LIGO-T0900334-v2

ADVANCED LIGO

Response to:
Stray Light Control PDD Comments

This document responds to the questions posed by the SLC PDR committee.

Figure 1: Seismic motion of vacuum manifold

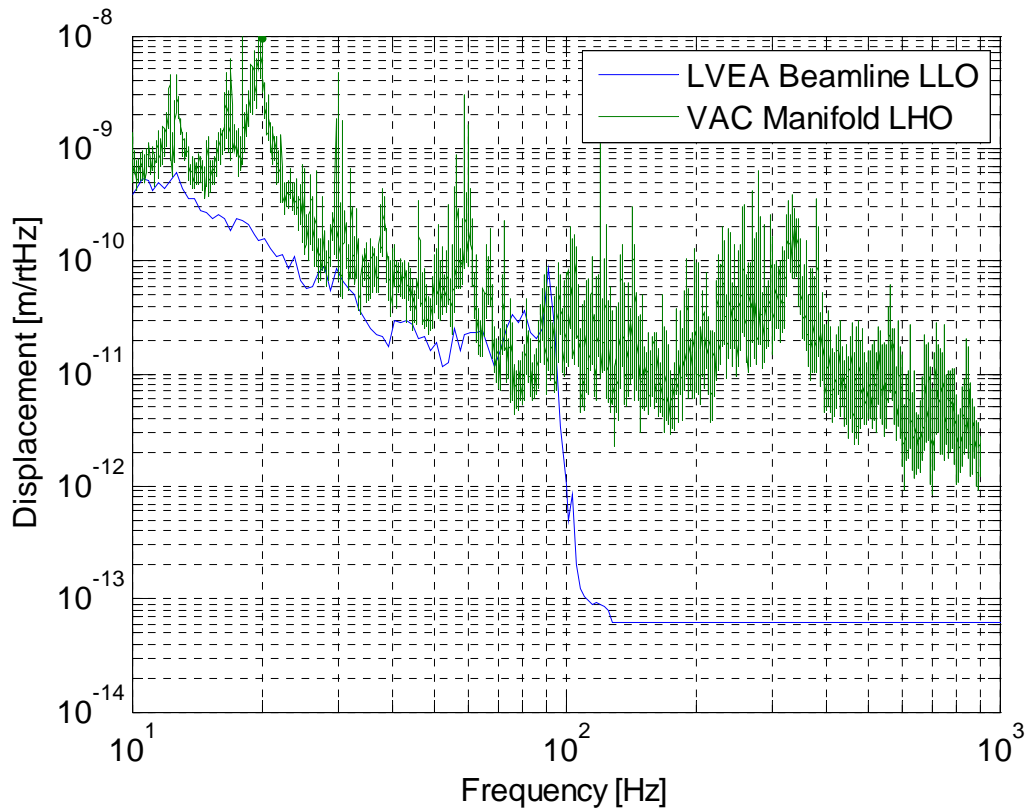
2.1 LLO BSC Wall Motion

The seismic motion of the LLO LVEA vacuum beam line (90% probability data) is compared with the seismic motion at LHO, which was used to calculate the scattered light, as shown in Figure 1. See T0900312-v1, Reference Seismic Data for LLO

The following scattered light sources depend upon the vacuum manifold motion, and would actually be less at LLO:

Figure 2: BSC ISI “0” Motion Spectrum

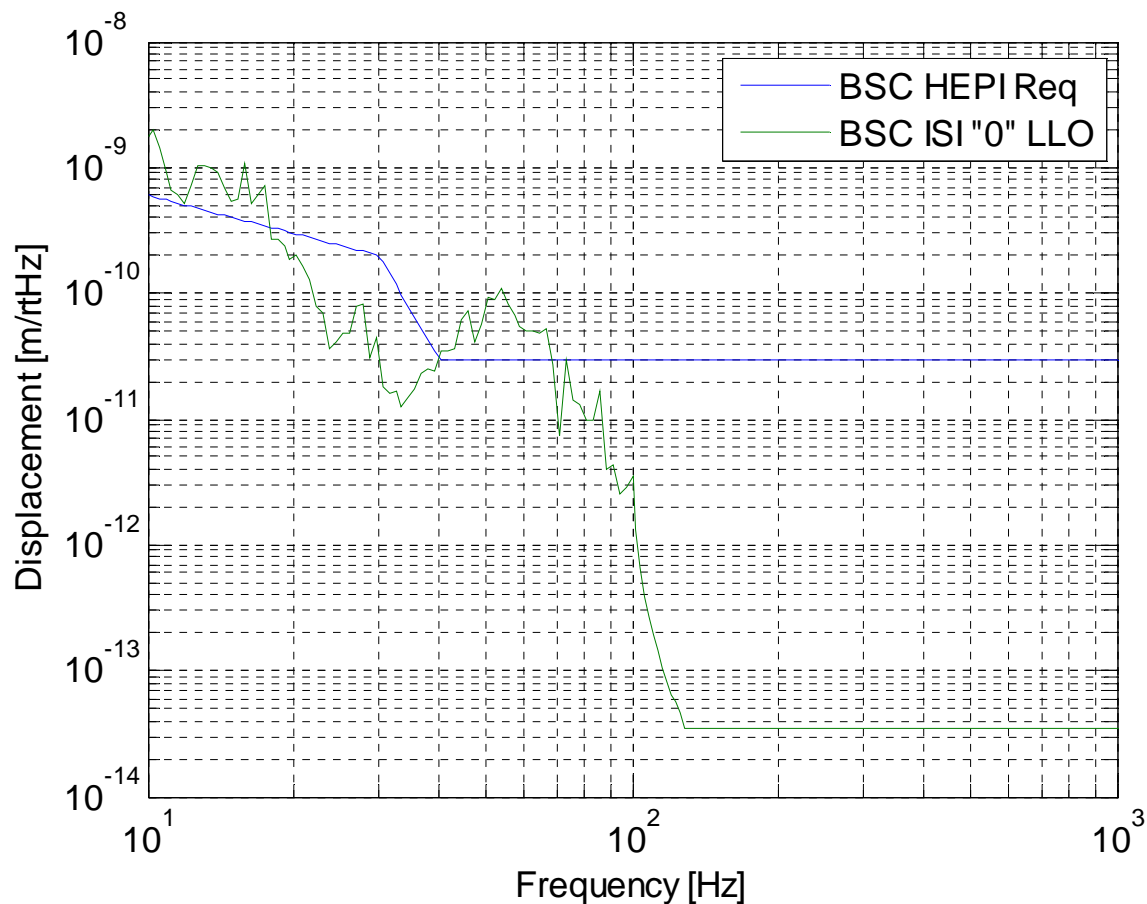
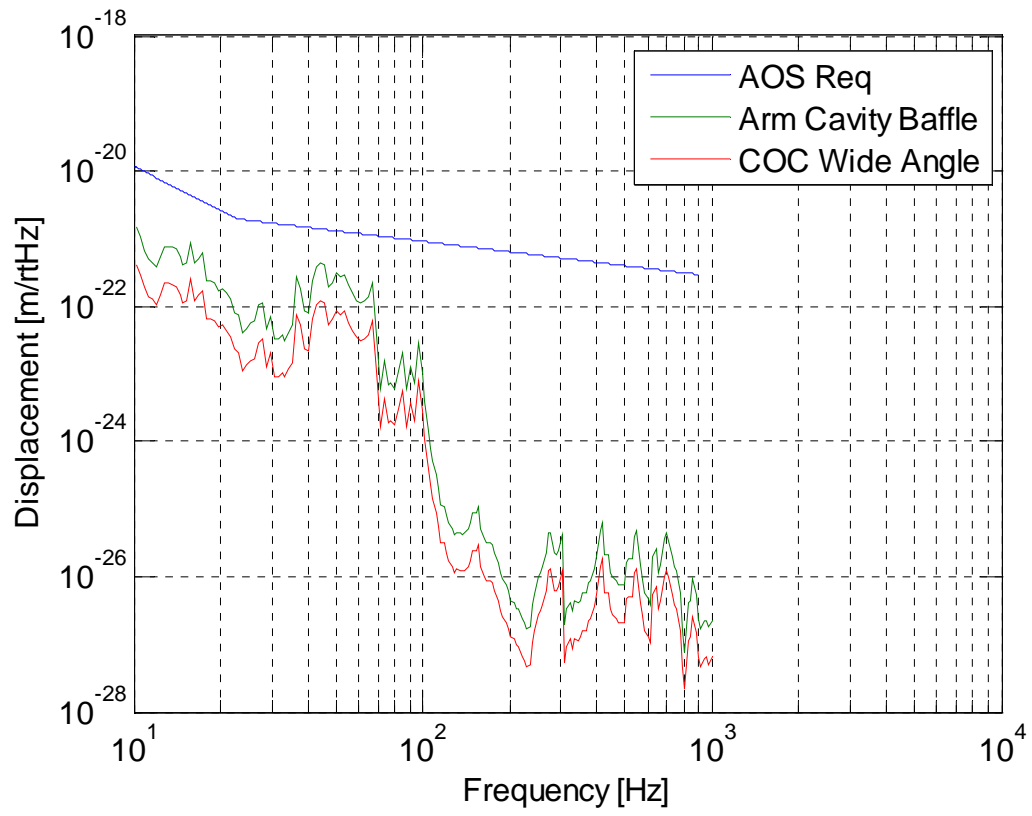
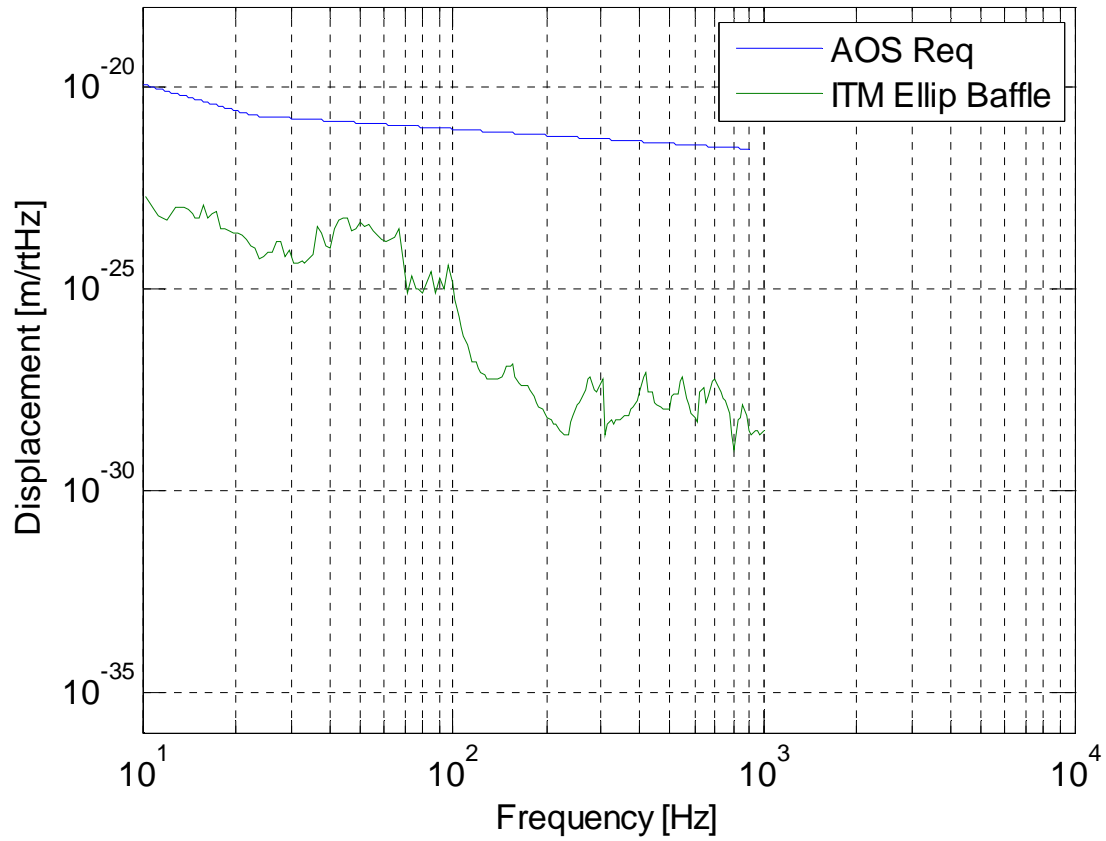
2.2 Noise Assessments for Expected LLO BSC HEPI Motion

A comparison of the ISI “0” (HEPI) motion and the Brian Lantz SEI elog entry ID: 596, 3/14/06, is shown in **Figure 2**.

The Arm Cavity Baffle, the COC Wide Angle Baffle, and the Elliptical Baffle are all suspended from the BSC ISI “0” ring. The scattering was recalculated using the measured LLO BSC ISI “0” ring motion.

Figure 3: Scattered Light Noise from all Oxidized SS Baffle Surfaces

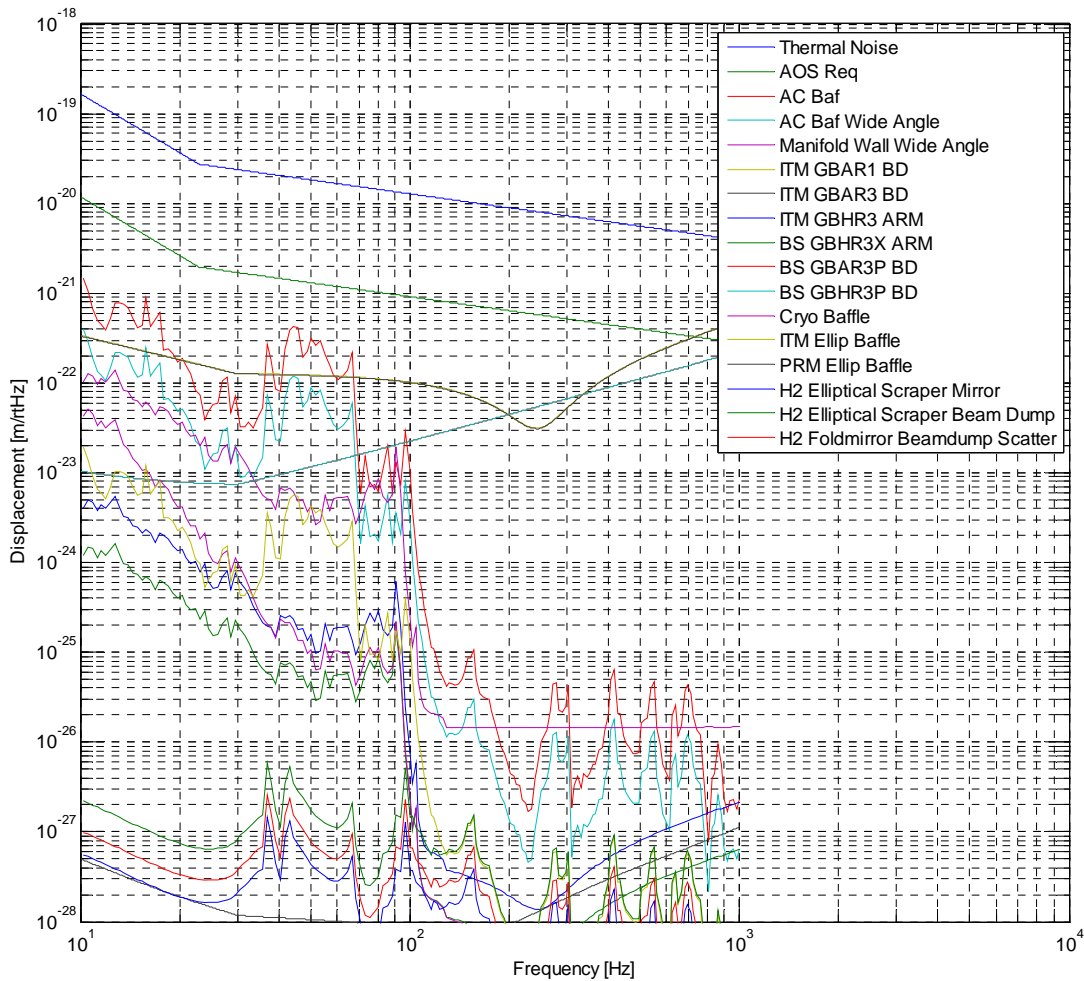
2.3 Need for Better Baffle Material?

The scattered light displacement noise from all oxidized SS baffles and beam dumps is shown in Figure 3. The BRDF of oxidized SS gives an adequate margin for all of the surfaces.

Figure 8: Displacement Noise of PR3, PR2, PRM, SR3, SR2, and SRM hitting the chamber walls.

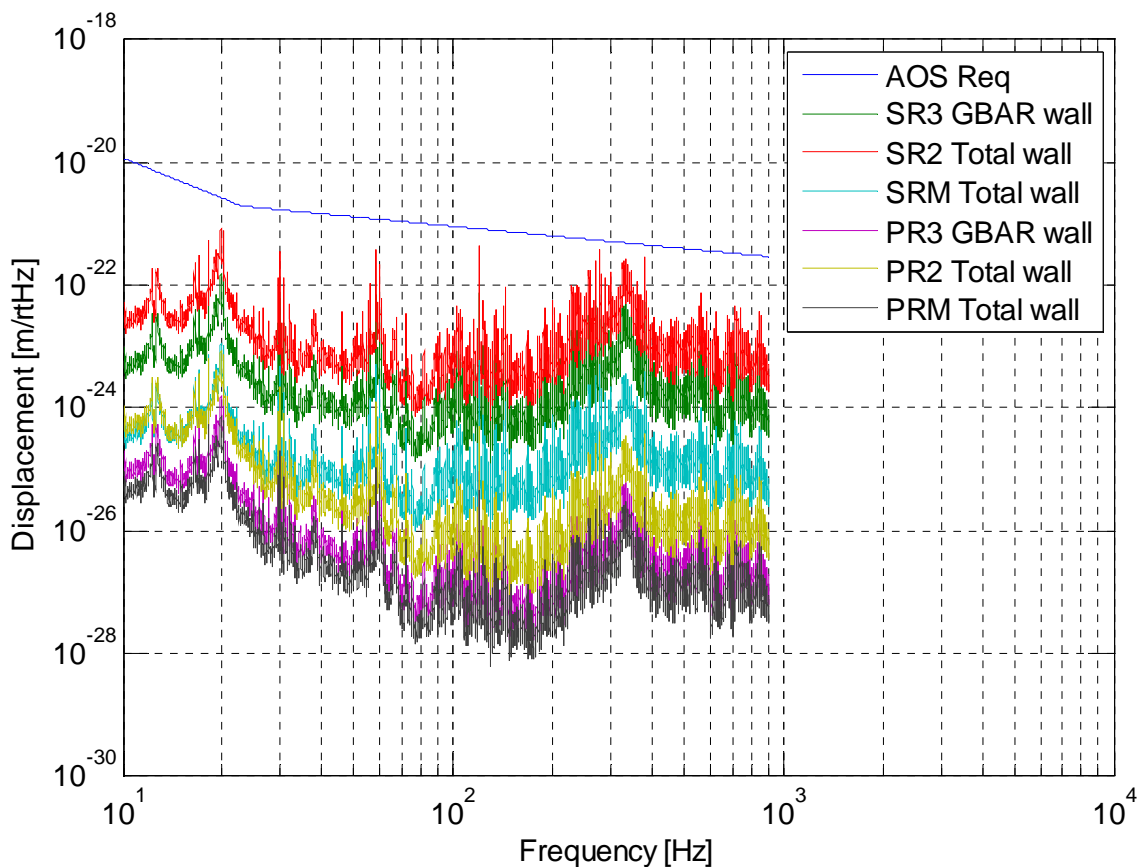
2.4.5 Do We Need PRM, SRM, PR2, SR2, PR3, SR3 Plate Beam Dumps?

The displacement noise from the PRM, PR2, and PR3 ghost beams, if they were allowed to hit the chamber walls, is several orders of magnitude below the AOS requirement, as seen in Figure 8.

The beam dumps for PR3, PR2, and PRM cause negligible displacement noise and will be eliminated.

The PRM plate beam dump will be retained as an errant beam baffle to protect the AR side of the PRM from an errant SM2 mirror. The errant beam baffle will be made of silicon carbide.

The beam dumps for SR3, SR2, and SRM will be maintained.

Figure 10: Transfer Functions for Eddy Current Damping: (blue curve) suspended damping plate, (green curve) eddy current damping plate mounted to frame

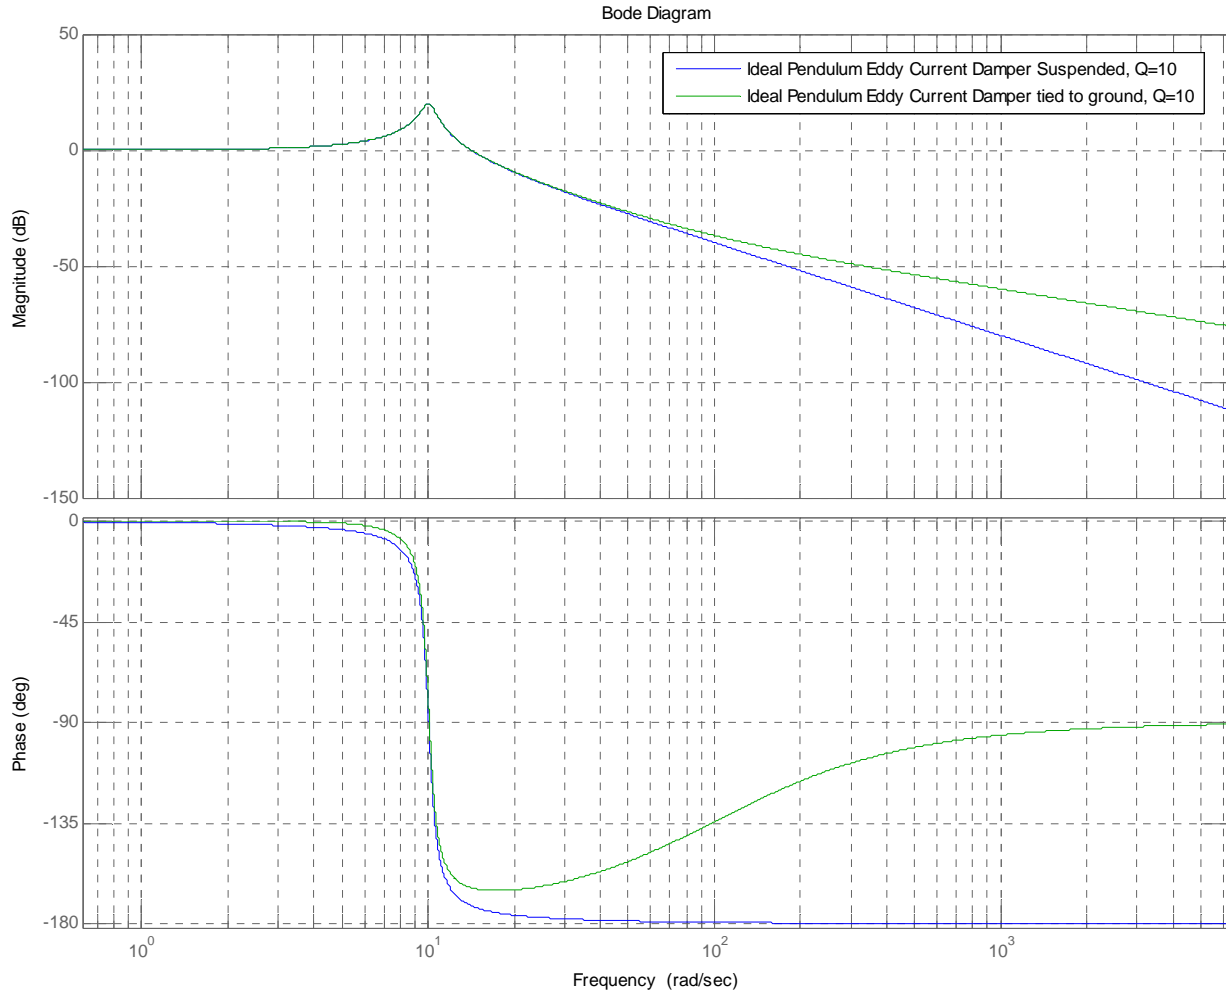
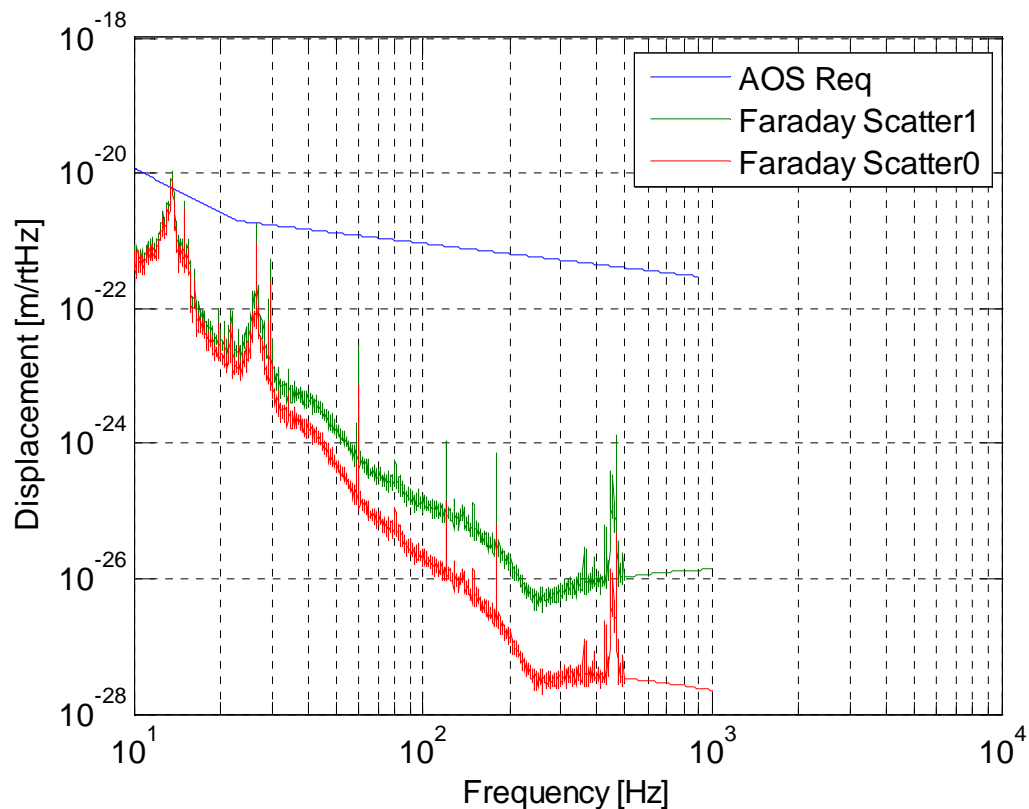
2.5.3 Eddy Current Damping Plate: Suspended or Attached to Frame?

The calculated horizontal motion transfer functions for the Output Faraday Isolator suspension are shown in Figure 10. The green curve corresponds to the eddy current damper being mounted directly to the suspension frame.

The scattered light displacement noise from the Input Faraday Isolator mounted to the HAM ISI platform is shown in Figure 11. Faraday Scatter1 is calculated with the eddy current damper attached to frame, and Faraday Scatter 0 is calculated with the eddy current damper suspended by a simple pendulum.

Therefore within the 10 – 1000 Hz range, the isolation is adequate if we attach the magnetic damping plate directly to the suspension frame.

Figure 13: Horizontal transmissibilities of the elliptical baffle suspensions for the o-ring type (green) and the short thick wire (blue).

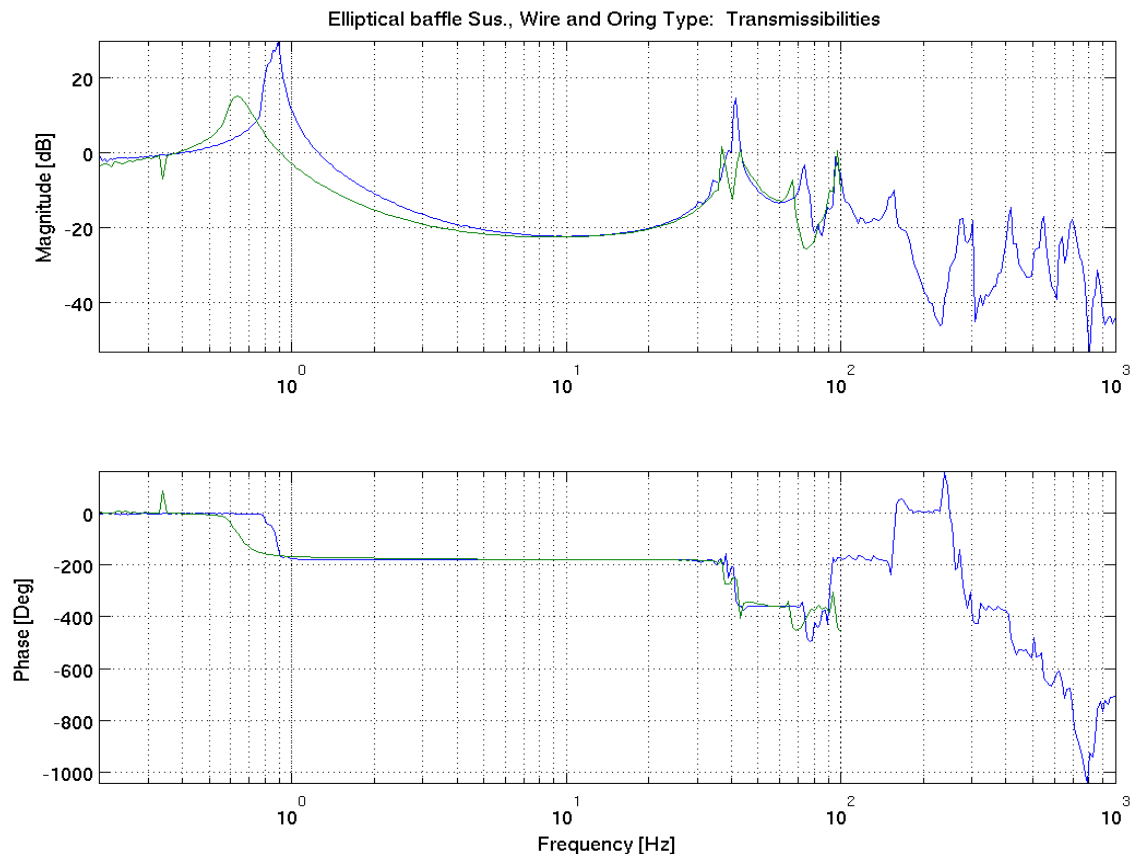
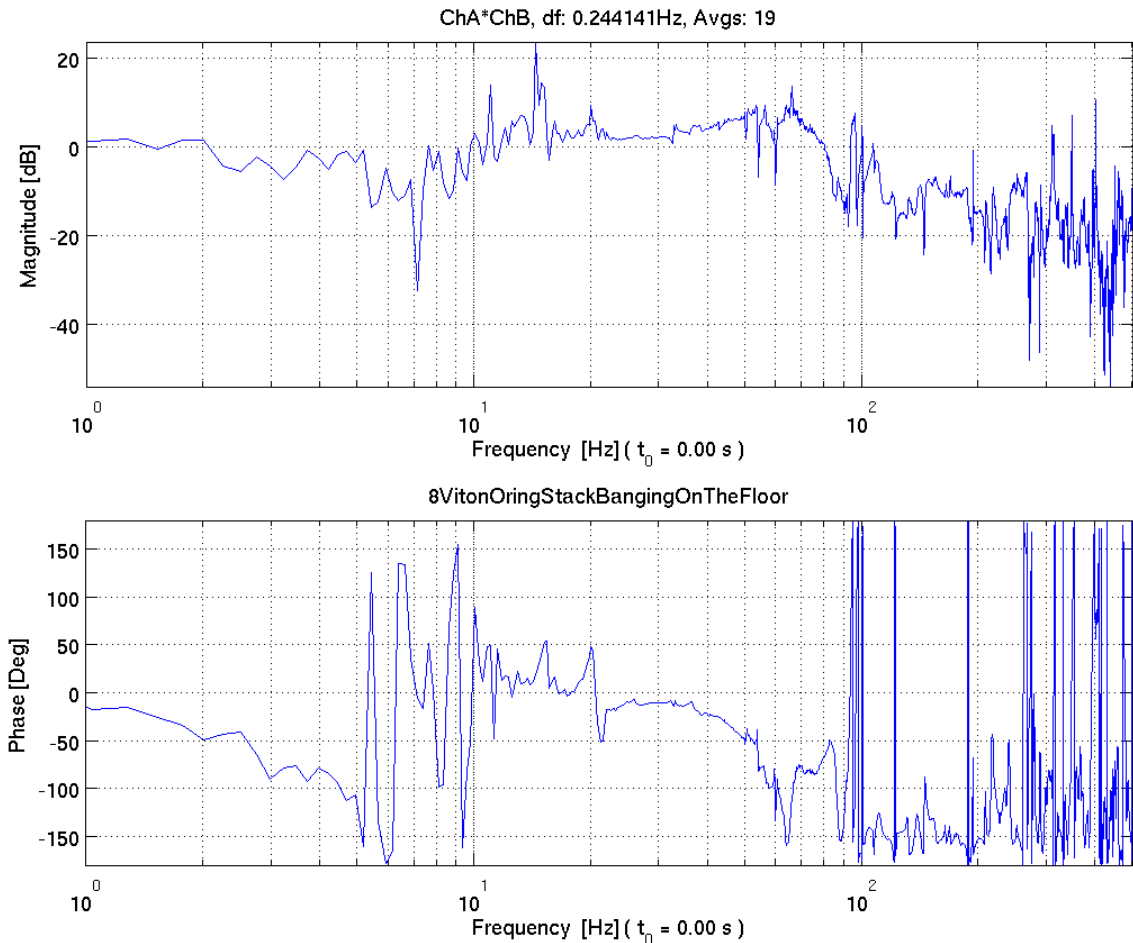
2.6.2 Viton O-ring Suspension Data

Figure 13 shows the measured transmissibility of the two elliptical baffle suspensions prototypes for the horizontal direction. The green curve is the o-ring type suspension transfer function and the blue curve is the short wire type suspension. The o-ring suspension provides damping for both the pendulum mode and also the internal modes of the steel tube connecting the payload to the suspension point.

Figure 14 shows the vertical transmissibility with a stack of 8 viton o-rings measured using the impulse response technique. Only this measurement method could be used because the set-up did not allow vertical excitation of the suspension. This technique works reasonably well at high frequency, but has the difficulty of exciting the low frequency band below ~5Hz. The measurement shows some amount of vertical attenuation above 70 Hz. The vertical fundamental mode has a quite poor quality factor and therefore the resonance is difficult to determine from this type of measurement; it is probability between 10 Hz to 30Hz

Internal modes of the suspension tube can affect the performance of the ISI control loops. To minimize the recoiling effect of these modes against the ISI platform one could use visco-elastic materials around the suspension tube itself to lower the quality factor of the lowest modes.

In addition, the tube internal modes can be moved to a higher frequency by reducing the tube mass and reducing the wall thickness from 1.6 mm to 1mm, by changing the length-diameter ratio, and by adding light stiffeners along the tube. However, it may be difficult to move those resonances above 100 Hz.
